City of Plymouth Planning Commission

Regular Meeting Agenda

**Special Land Use and
Site Plan Review
For
Plymouth, Michigan**

Applicant:	Bryan Bender Fortisnet Lease 30445 Northwestern Highway Farmington Hills, MI 48334
Project Name:	Scooter's Coffee Drive-Thru
Plan Date:	September 17, 2021
Location:	1490 W. Ann Arbor Road
Zoning:	ARC – Ann Arbor Road Corridor District
Action Requested:	Special Land Use and Site Plan Approval
Required Information:	Any deficiencies are noted in the report.

PROGRESSIVE ae
SCOOTER'S COFFEE
NOT FOR CONSTRUCTION
 1490AVOSTARPAKOUUUAUUEULYMUWTPMIA8170
 FILE NUMBER 91880004
 PROJECT MANAGER JPM
 PROFESSIONAL DRAWN BY SRV
 CHECKED BY
LANDSCAPE PLAN L1.01

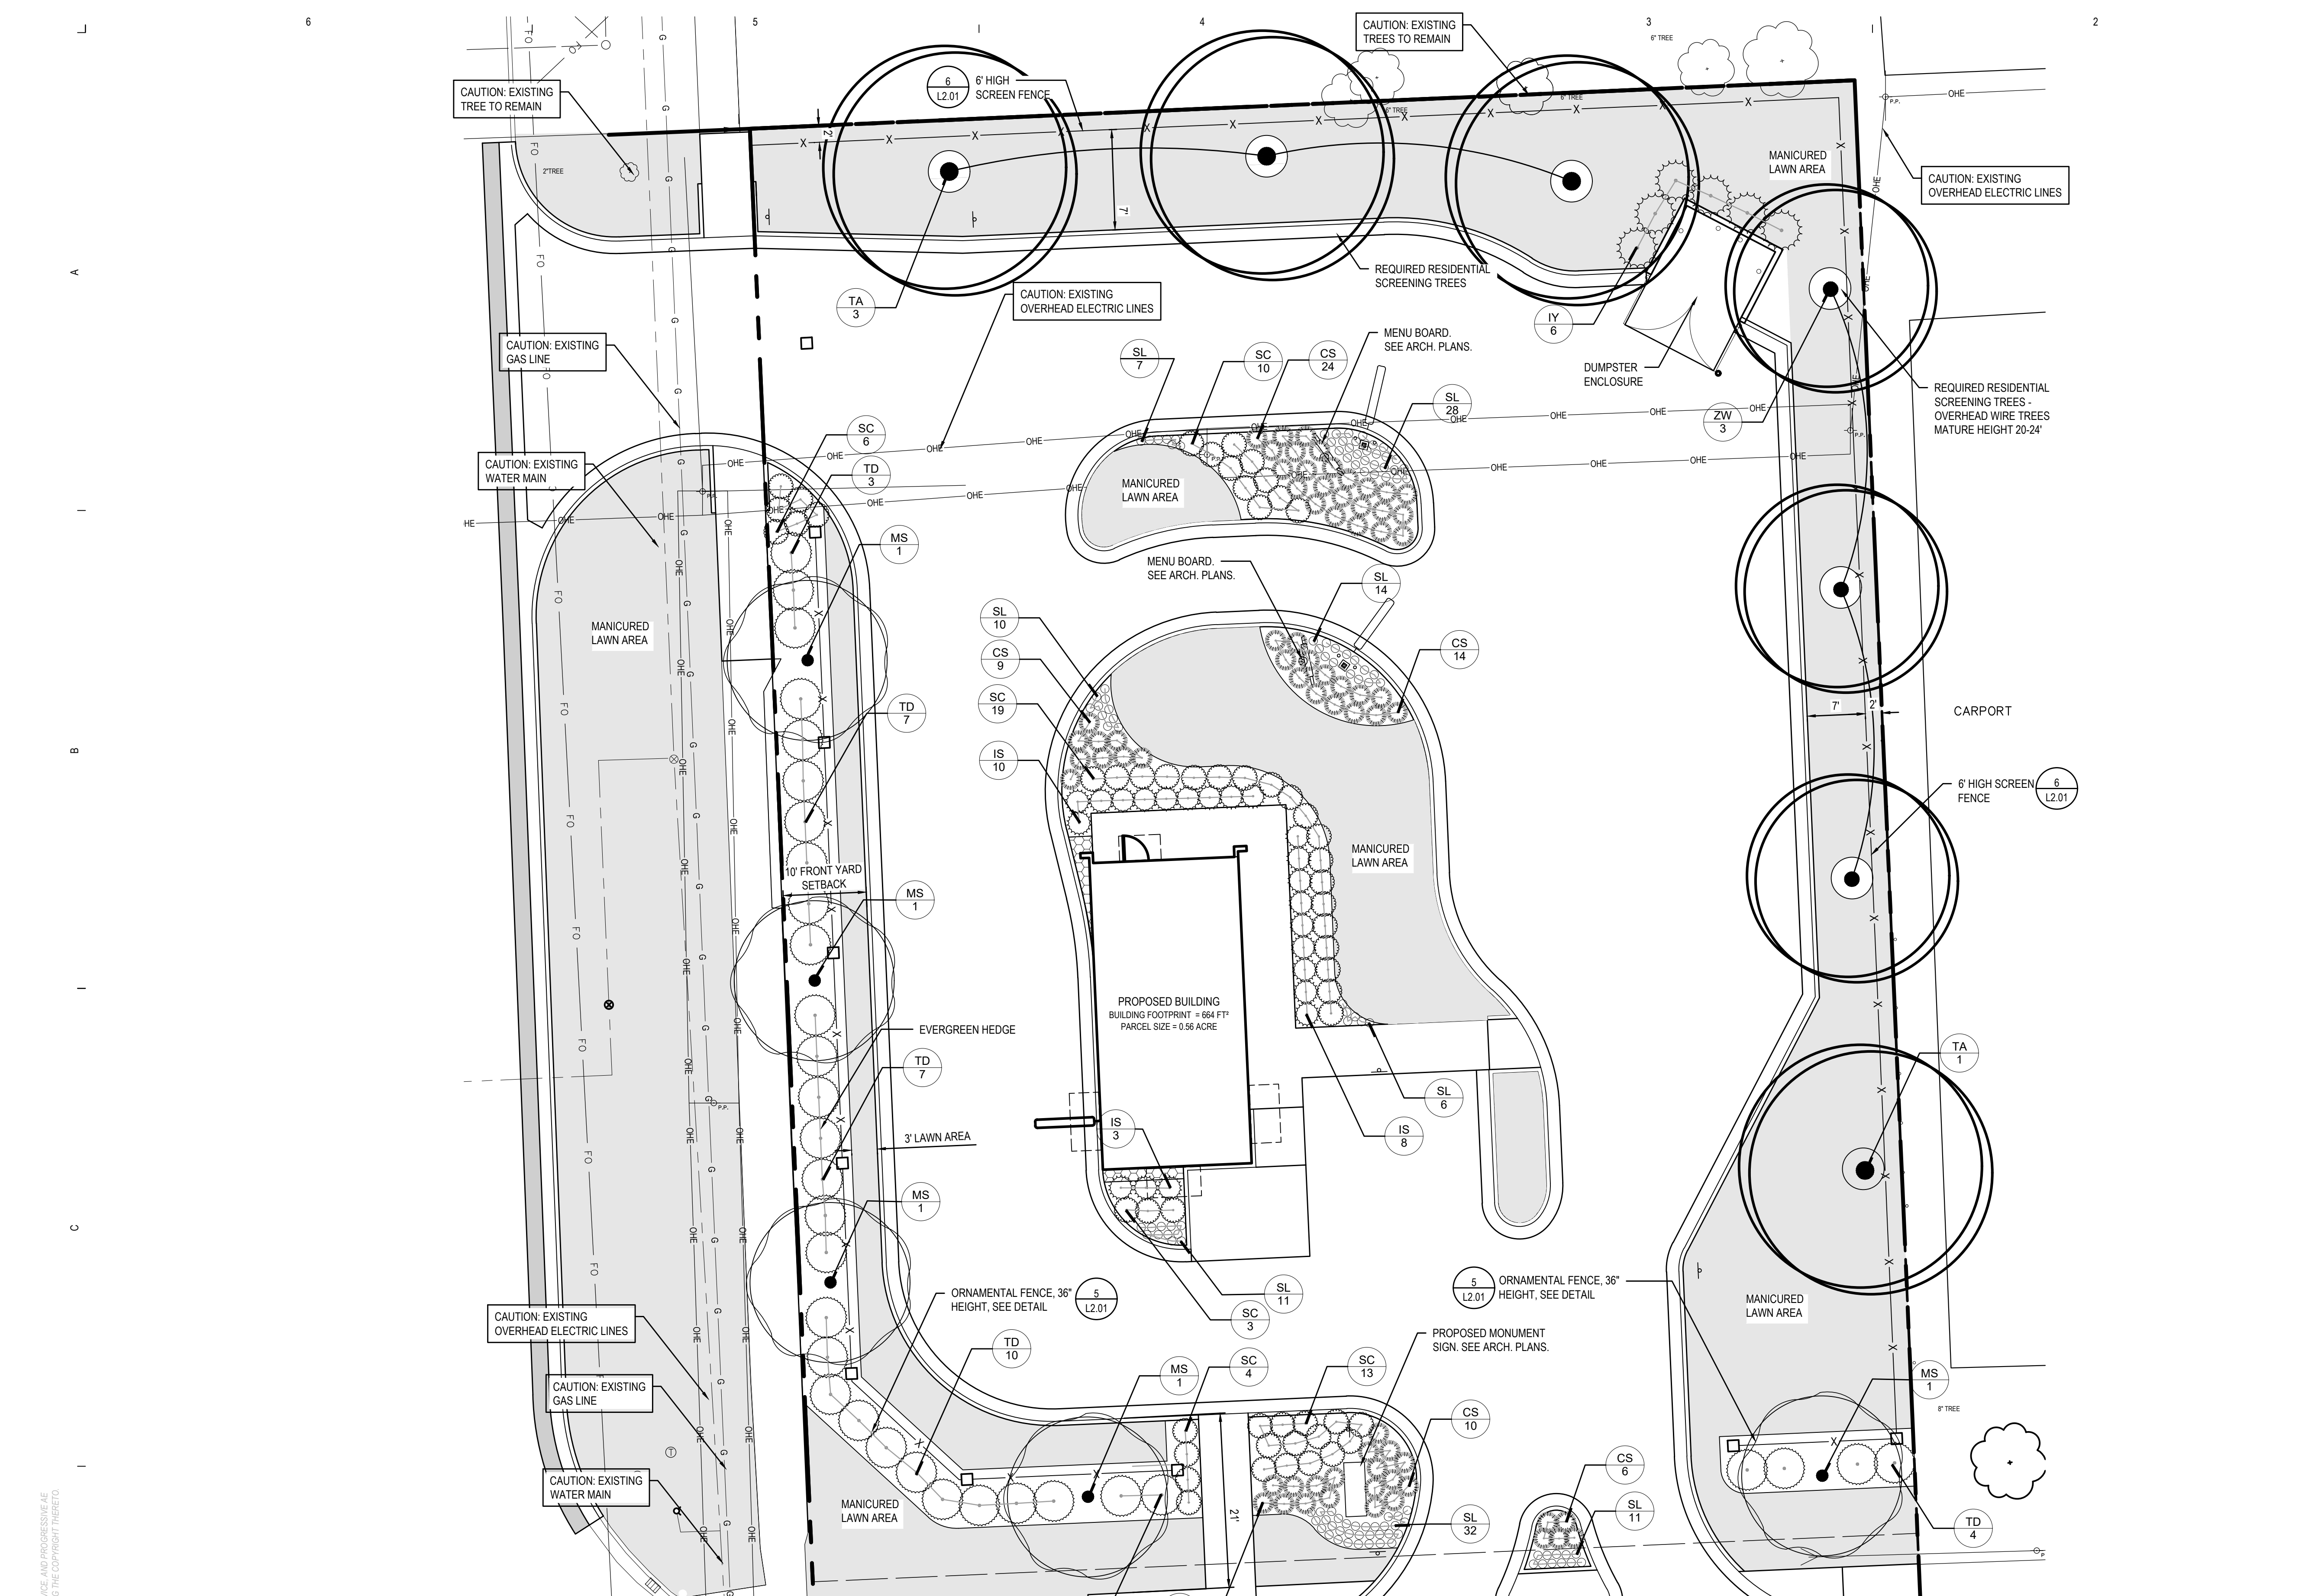
- Sheet L1.01 Add note to plans that an irrigation system supplying water to turf, and all plant material shall be provided, including the areas in the road right-of-way.

- Sheet L1.01, Note #3 should specify 4" of top soil for all lawn, groundcover and planting beds.
- Sheet L1.01. Landscape maintenance procedures need to be specified on this sheet.

6 SCREEN FENCE
NOT TO SCALE

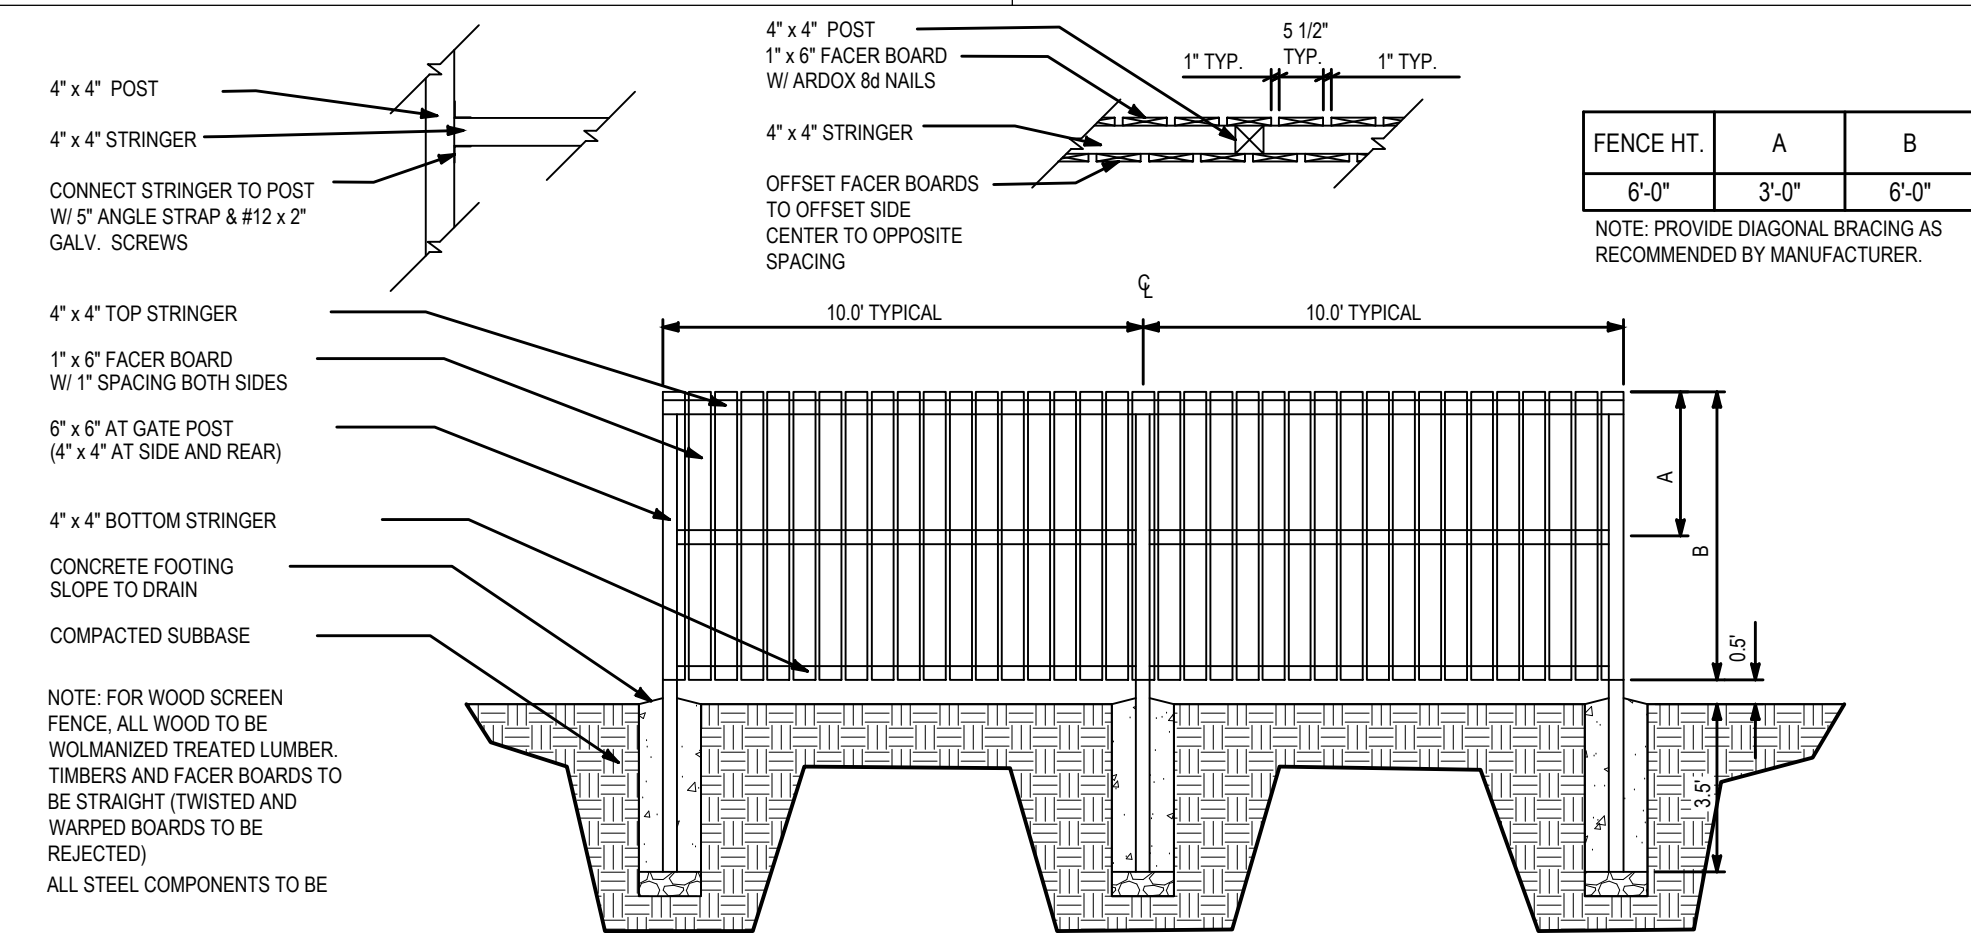
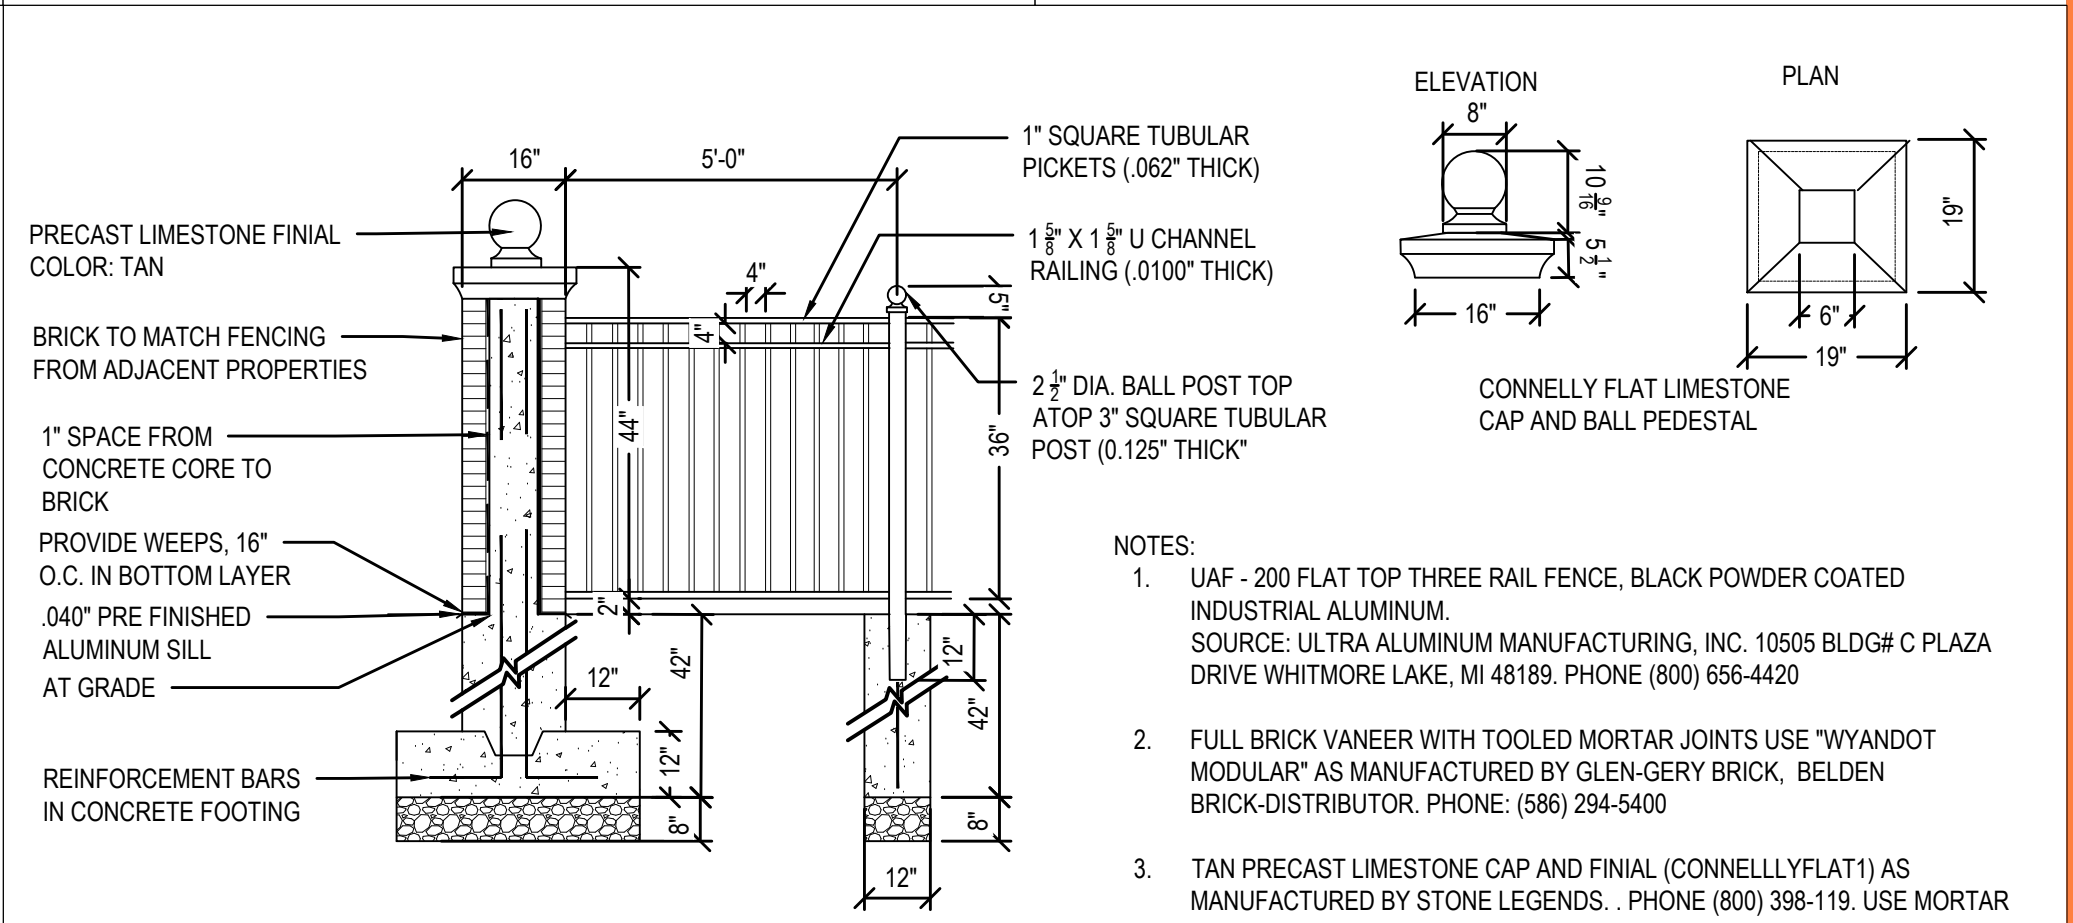
- Sheet L2.01. Section 78-171 ("Ann Arbor Road Standard Design Details"). The designer has created their own detail for the aluminum fence/masonry pier to add structural details. However, some manufacturer information is missing that is on the standard detail. The details on the plans should include all information on the standard details. Also, a note should be added that states: "The streetscape elements shall be consistent with the standards and requirements of the Ann Arbor Road Streetscape Prototype, "Ann Arbor Road Standard Design Details," dated October 16, 2003,

- Sheet L2.01. Tree and shrub planting details should specify 4-inches hardwood shredded bark mulch.
- Sheet L2.01. Add tree protection detail to this sheet. Also, a symbol showing tree protection techniques shown around all trees to remain needs to be added on the Demolition Plan (Sheet C1.01), including the existing tree in the Sheldon Road right-of-way (just outside northwest corner of project site).
